Watts Bar Nuclear Plant, Unit 2
NRC Docket No. 50-391

Subject: **Watts Bar Nuclear Plant (WBN) Unit 2 - Response to Requests for Additional Information (RAIs) Regarding Inadvertent ECCS Actuation Analysis, and Chemical & Volume Control System Malfunction Analysis**

RESPONSE TO RAI CONCERNING WATTS BAR UNIT 2 INADVERTENT ECCS ACTUATION ANALYSIS

RESPONSE TO RAI CONCERNING WATTS BAR UNIT 2
CHEMICAL & VOLUME CONTROL SYSTEM (CVCS) MALFUNCTION ANALYSIS

Figure 15.2-42a Inadvertent Operation of the Emergency Core Cooling System - Nuclear Power and Core Average Temperature Response

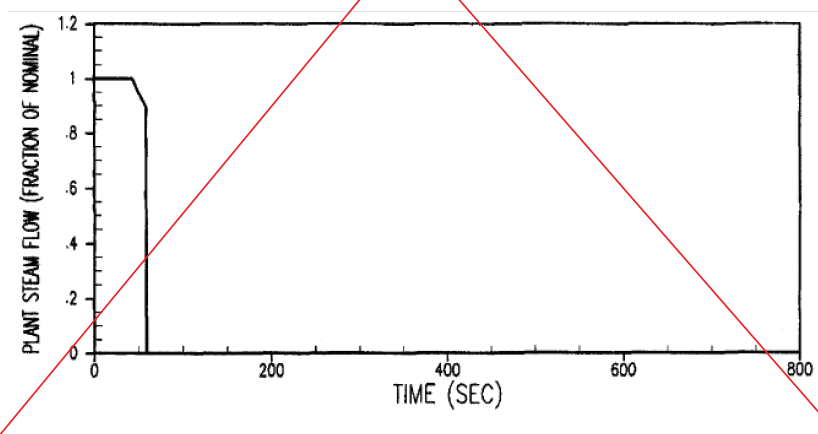
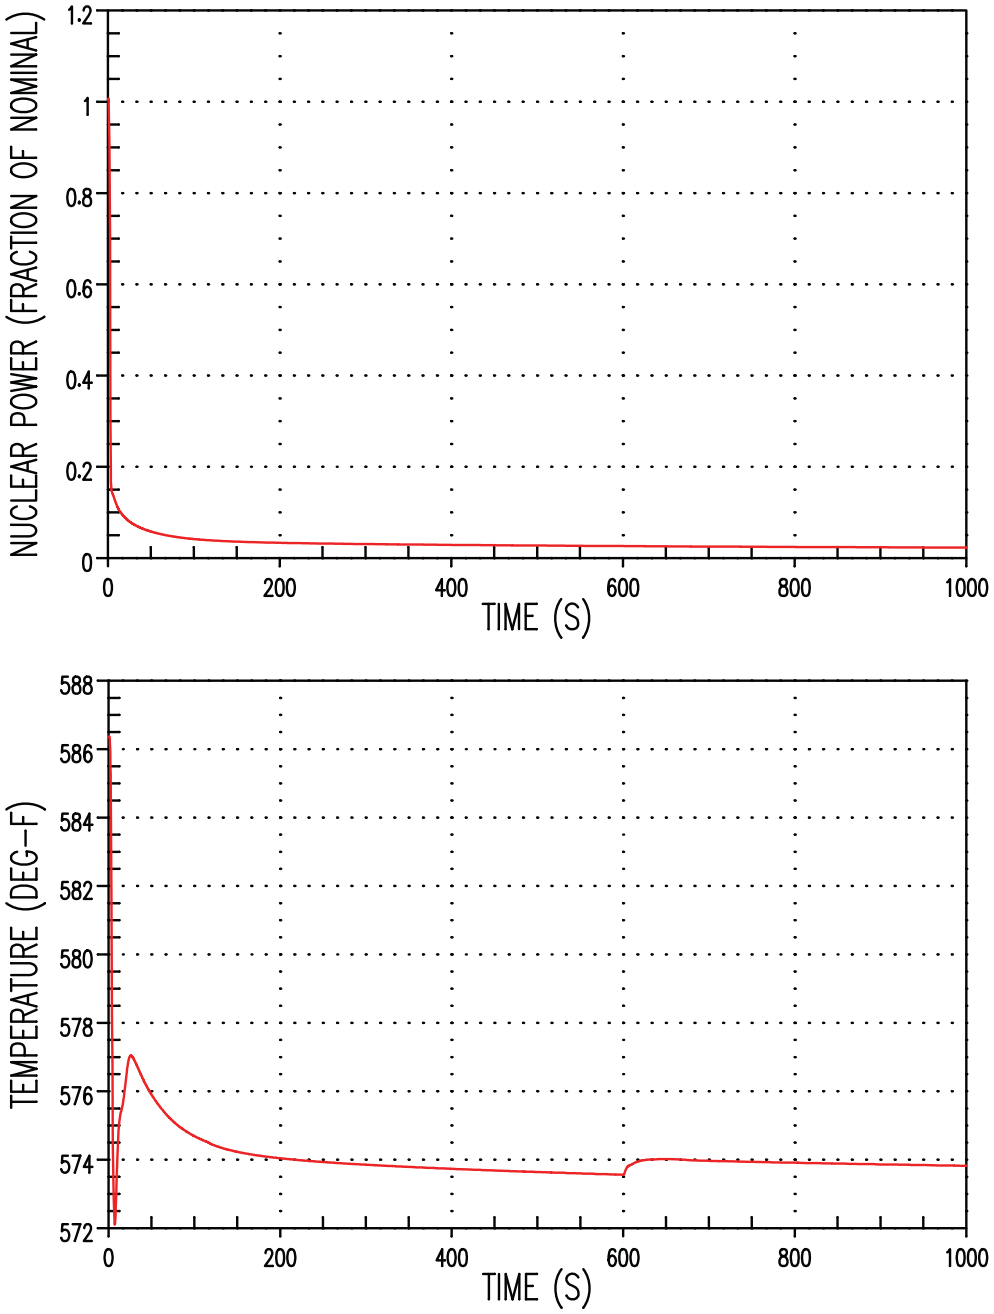
During the audit, TVA was asked to reanalyze the Inadvertent ECCS event to be consistent with the concerns documented in NRC Regulatory Issue Summary 2005-29.

Replace with the figure on the next page

~~Figure 15.2-42a Inadvertent Operation of Emergency Core Cooling System - Nuclear Power& Steam Flow Response~~

The results of the updated analysis demonstrate that the pressurizer reaches a peak water volume of 1,732 ft^3 at approximately 667 seconds, compared to the total pressurizer volume of 1,846 ft^3 (including the surge line volume). The pressurizer does not go water solid during the event, assuming operator action time at 10 minutes to terminate injection flow. Therefore, neither the pressurizer power-operated relief valves (PORVs) nor the pressurizer safeties open while a water-solid condition exists in the pressurizer and the non-escalation acceptance criterion is met.

The transient responses for the ~~minimum DNBR and~~ pressurizer filling case~~s~~ are shown in Figures 15.2-42a through 15.2-42c. Table 15.2-1 shows the calculated sequence of events. for both the minimum DNBR case and the pressurizer filling case.

Figure 15.2-42b Inadvertent Operation of the Emergency Core Cooling System – Pressurizer Pressure and Pressurizer Water Volume Response

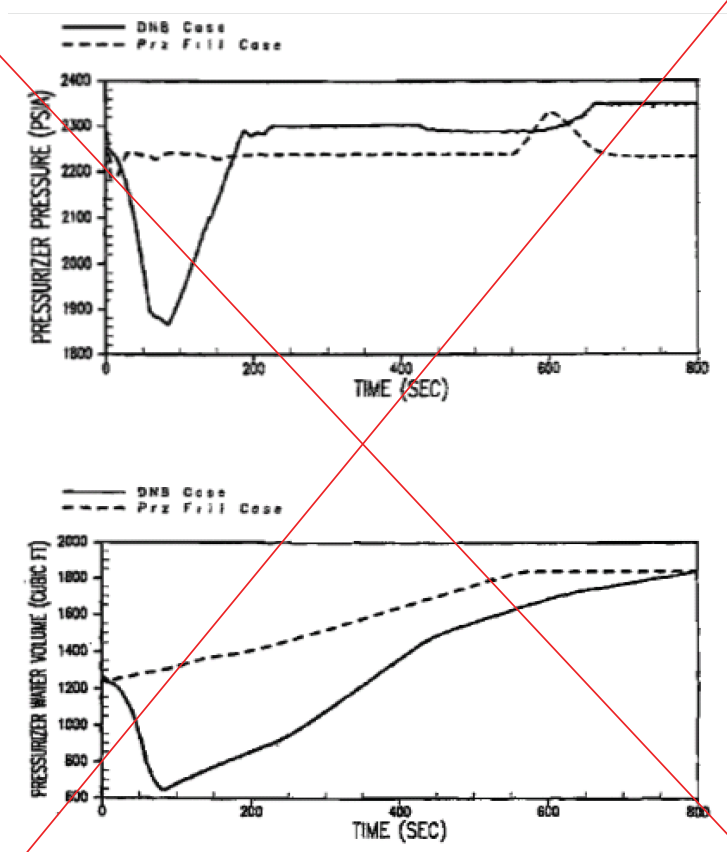
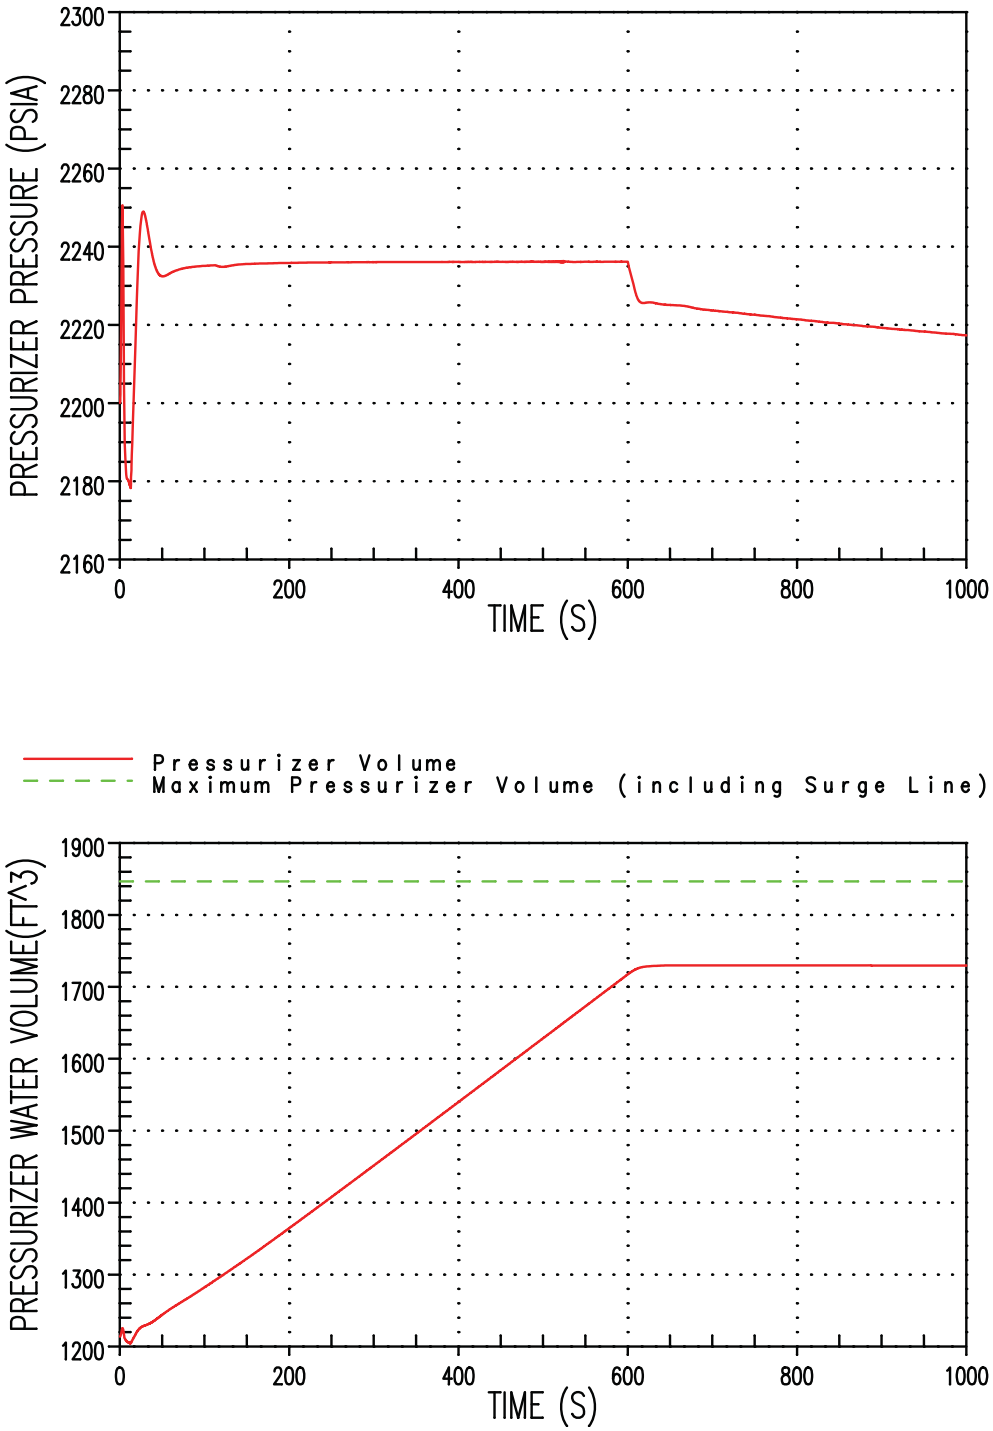
Replace with the figure on the next page

~~Figure 15.2-42b Inadvertent Operation of Emergency Core Cooling System - Pressurizer Pressure & Water Volume Response~~

SI flow termination at 10 minutes prevents the pressurizer from filling.

Figure 15.2-42c Inadvertent Operation of the Emergency Core Cooling System – Maximum Emergency Core Cooling System Flow Rate

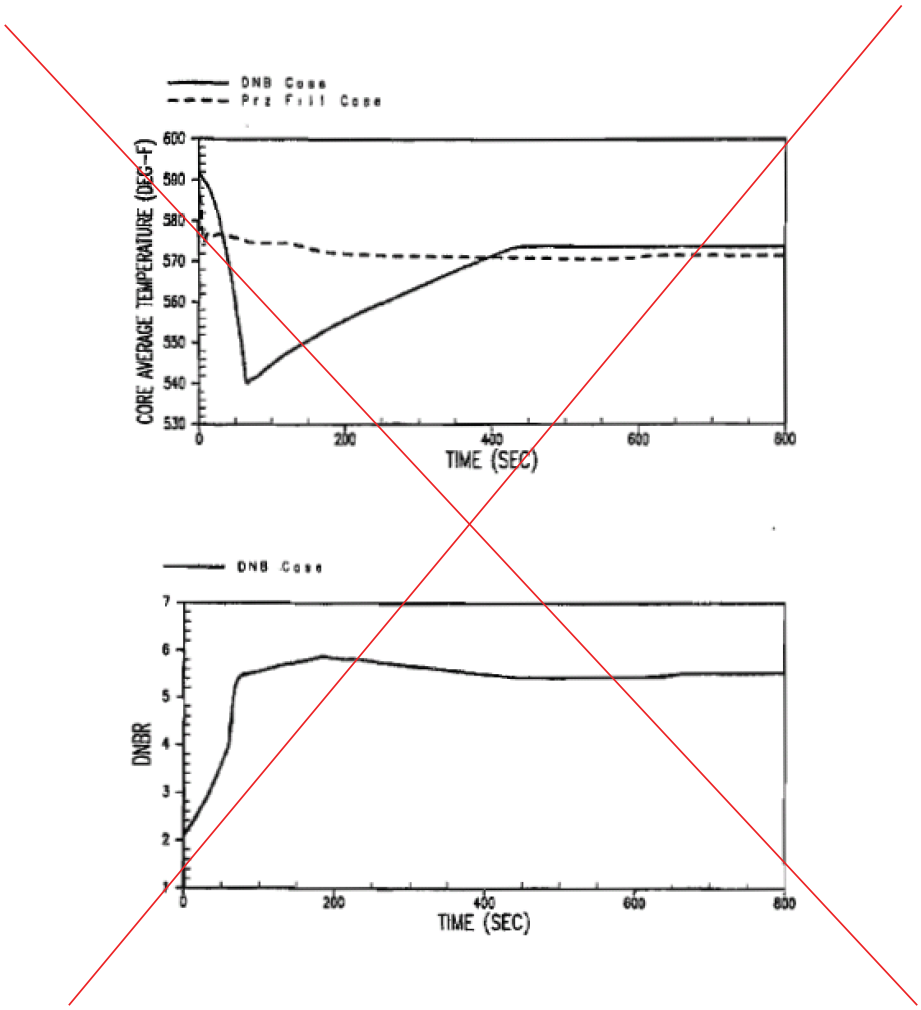
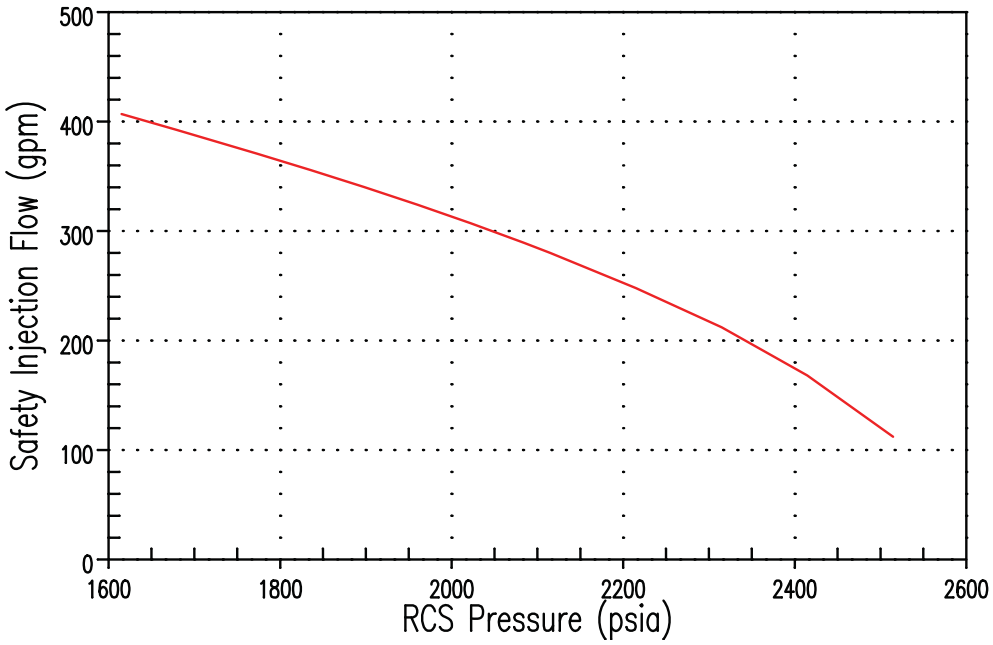
Replace with the figure on the next page

~~Figure 15.2-42c Inadvertent Operation of Emergency Core Cooling System - Core Average Temperature And DNBR Response~~

WATTS BAR NUCLEAR PLANT *FINAL SAFETY* *ANALYSIS REPORT*
CVCS MALFUNCTION NUCLEAR POWER VS. TIME FIGURE 15.2.15-1

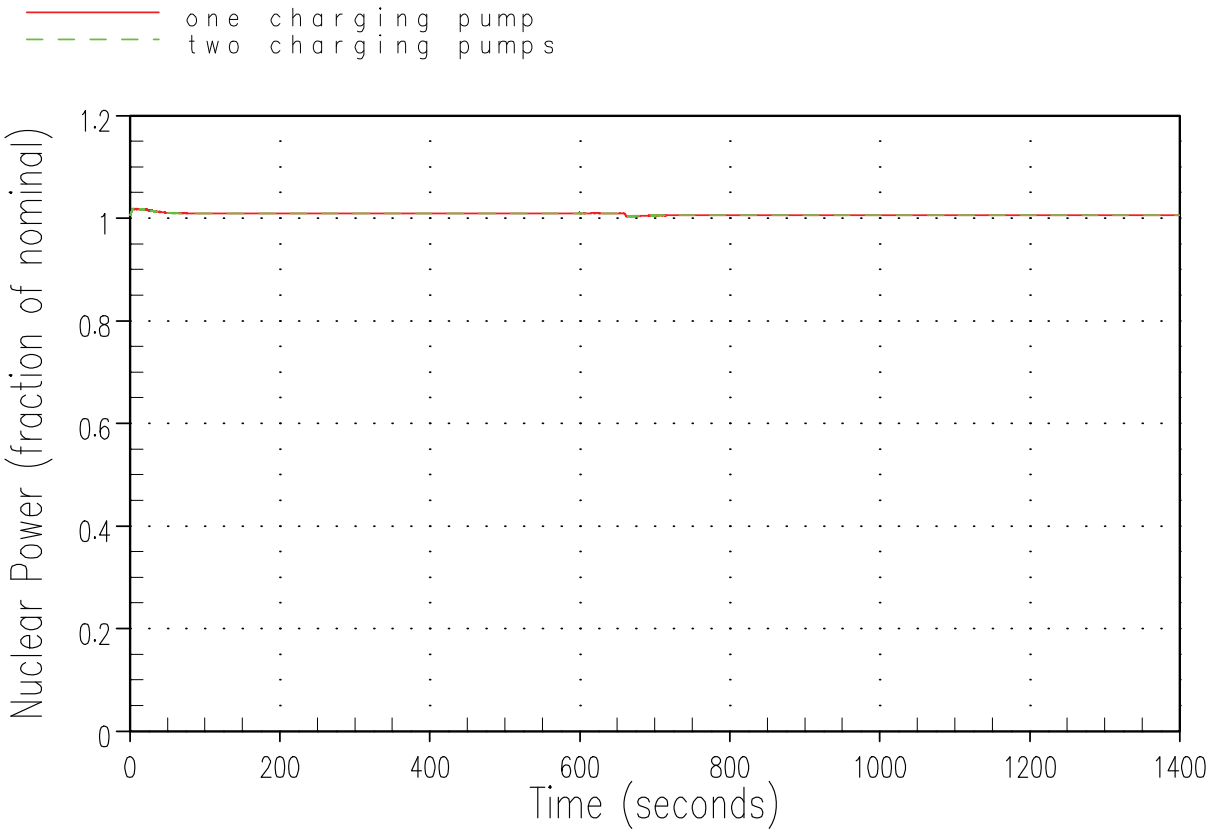
During the audit, TVA was asked to perform a CVCS malfunction analysis as required by NUREG-800, SRP 15.5.1-15.5.2.

The transient responses for the limiting CVCS system malfunction cases are shown in Figures 15.2.15-1 through Figure 15.2.15-4. Table 15.2.15-1 shows the calculated sequence of events. In all the cases analyzed, core power and RCS temperatures remain relatively constant.
